**AGENDA**  
**Cascade Charter Township Planning Commission**  
**Monday, May 9, 2022**  
**7:00 pm**  
**2870 Jacksmith Ave**

STAFF REPORT: Case # 22-3696/Luminar Technologies  
REPORT DATE: May 4, 2022  
PREPARED FOR: Cascade Charter Township Planning Commission  
MEETING DATE: May 9, 2022  
PREPARED BY: Brian Hilbrands, Planning Director

REQUESTED ACTION: Site Plan Review for a 26,520 sq ft building.

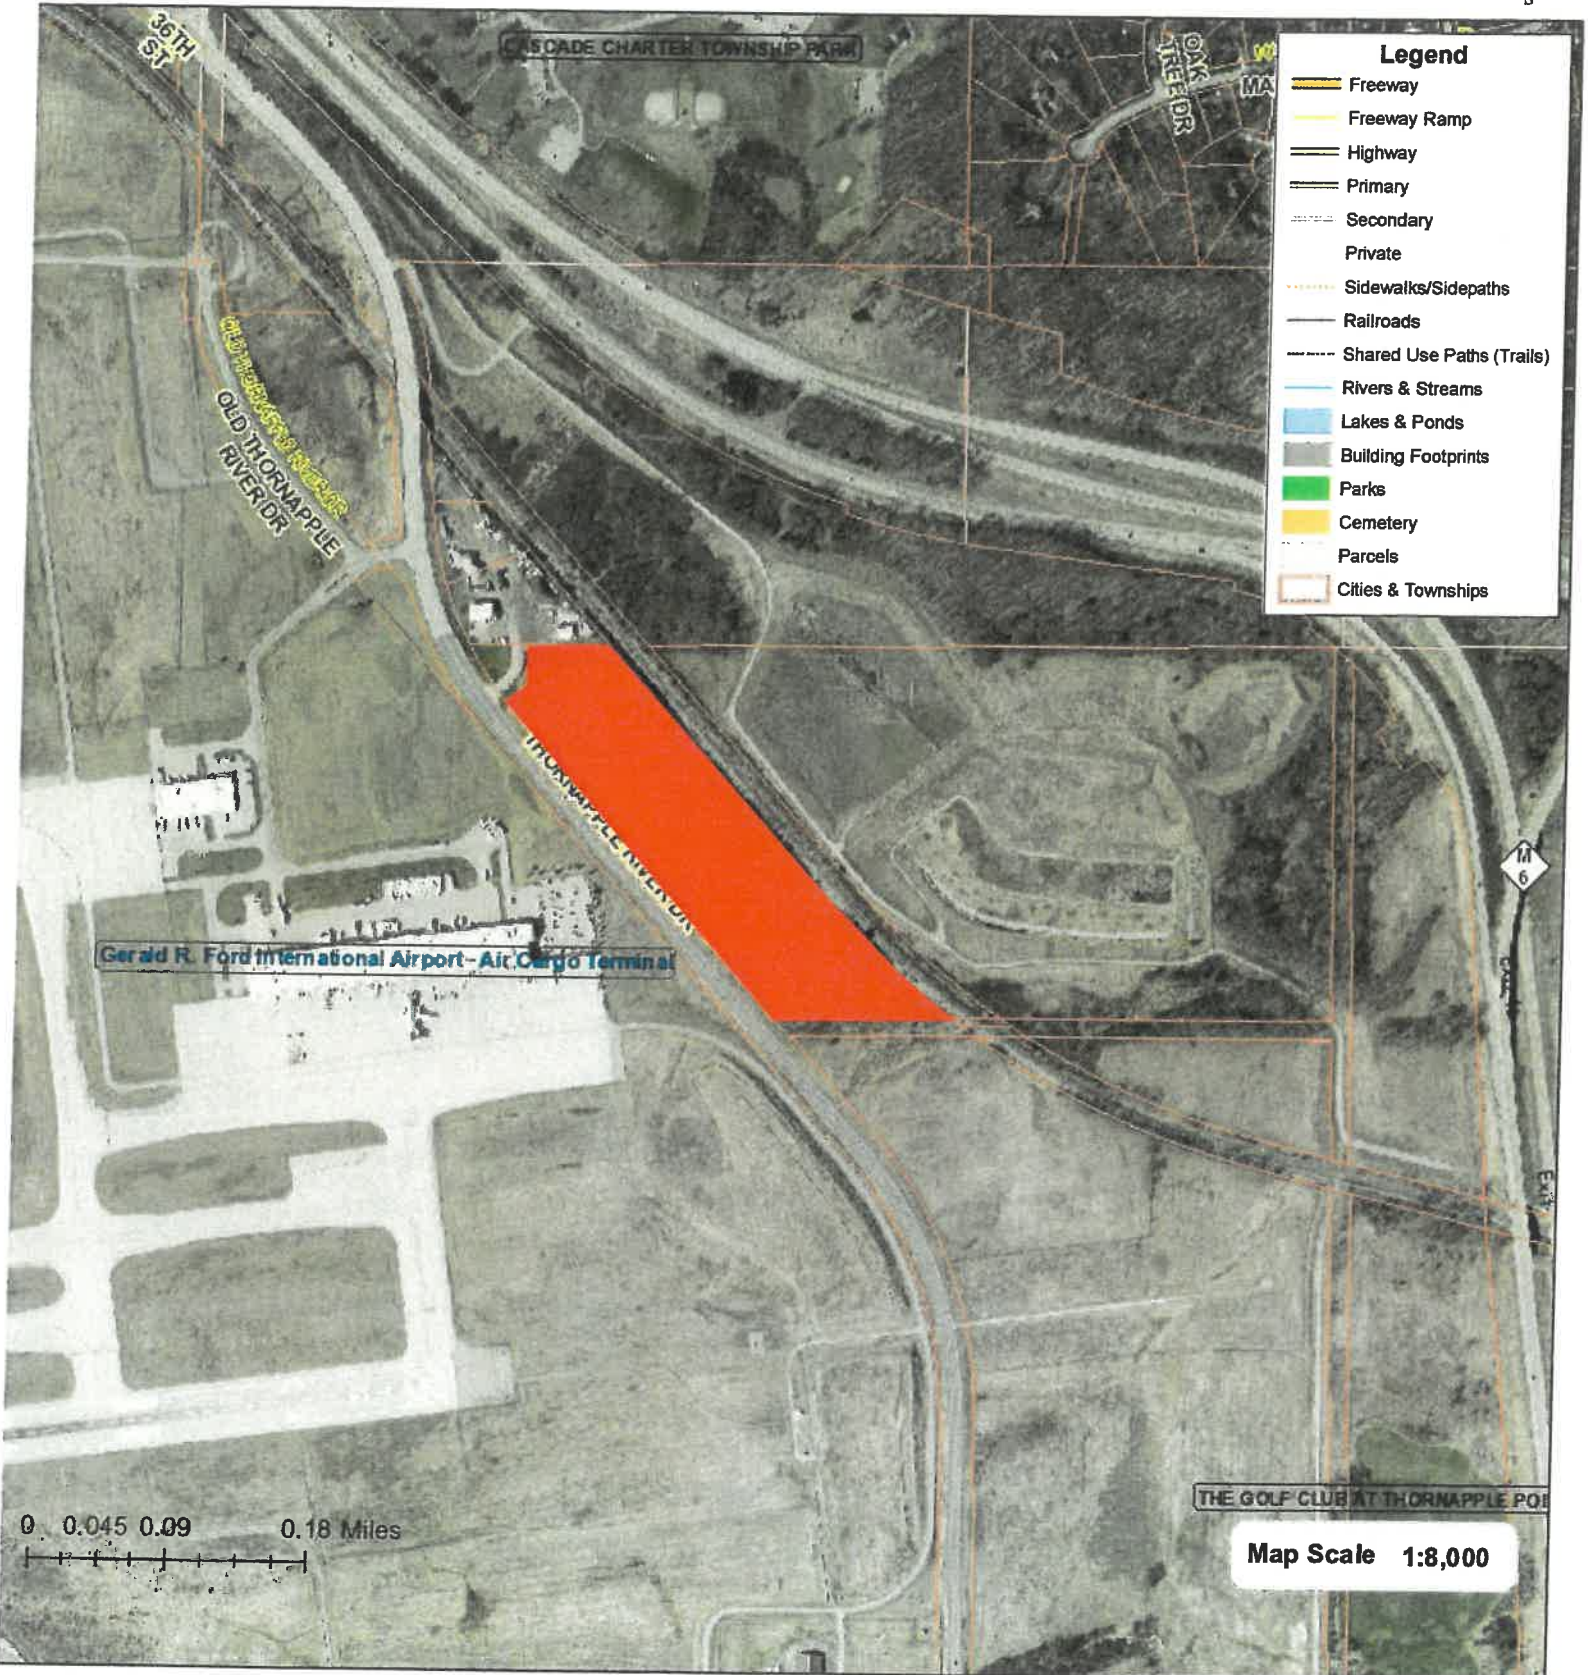
1. The applicant is requesting site plan approval to construct a 26' x 1,020' (26,520 sq ft) building. The site plan was reviewed under Section 21.07 of the Site Plan Review Chapter of the Zoning Ordinance.

2. The application was tabled at the April 18 Planning Commission meeting. The Planning Commission requested that the applicant provide renderings and information regarding the building's exterior. The applicant has provided renderings and those are included in the meeting packet. The Planning Commission also expressed concern regarding PFAS or contaminants possibly leaving the site.

4. The building meets the setback requirements of the zoning district.
5. While there is currently no landscaping being proposed, the site does meet the required bufferyard widths. If the use continues beyond the proposed 5-year period it will be expected that landscaping will be added.

6. The applicant has indicated that no exterior lighting will be included. If any exterior lighting is added the applicant will need to provide a photometric plan that meets Township requirements.

8. The site plan includes a 50' x 80' gravel area to be used for staging of construction equipment and then for parking. The applicant has indicated that the maximum normal vehicle capacity will be 5 vehicles. This would meet the minimum parking requirement of 1 space/employee. If the use continues beyond the proposed 5-year period it will be expected that the parking area and access drive be paved.

9. The plans show a future 26' x 640' addition to the building. Due to the size of the addition, the owner would need to come back for a site plan review before the addition could be constructed.
